IGEM/UP/10 Edition 4 - Interpretation of Clause 8.7.3.4 and Figure 7

ICOM Infosheets are created to provide information to the non-domestic heating industry.

The original graph and diagram of figure 7 published in UP/10

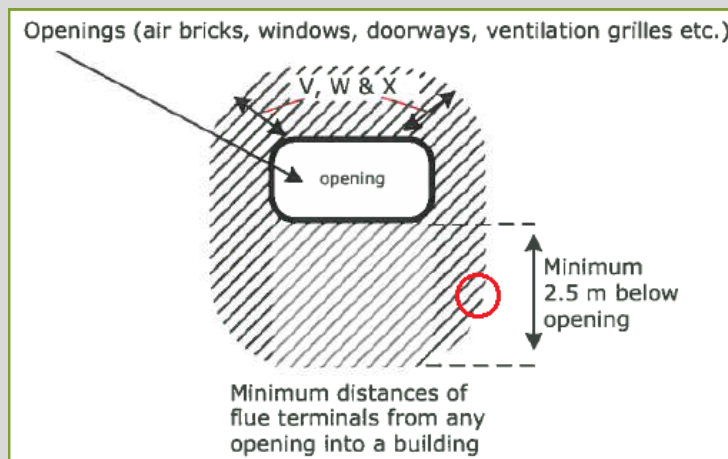
An issue has been raised with IGEM about the interpretation of clause 8.7.3.4 and figure 7 (page 39) for installations where a horizontal flue termination is lower than an opening. Figure 7 shows shaded areas around an opening in which flue terminations must not be positioned.

This has raised issues for an ICOM member, in a case where a terminal had been positioned below the opening and within distance X of a line dropped vertically down from the right-hand side of the opening (which is less than 2.5m, indicated by the red circle), and compliance was disputed.

Figure 7 is a bit confusing, the radius at the top of the opening is OK but below it should be a square (the radius as shown isn't from the opening so it would be difficult to apply because of the 2.5 min distance)."

ICOM members unanimously agree on the above response and would like to see figure 7 amended to show the squared corners shaded area forming a rectangle below the opening, rather than rounded corners.

"The view is that "X" is not a diagonal dimension but a horizontal (or vertical) distance from the terminal, i.e. a terminal must be below 2.5m below an opening and outside a band "X" from the edge of the opening, meaning that the prohibited area below an opening is the width of "X" horizontally and 2.5m vertically.
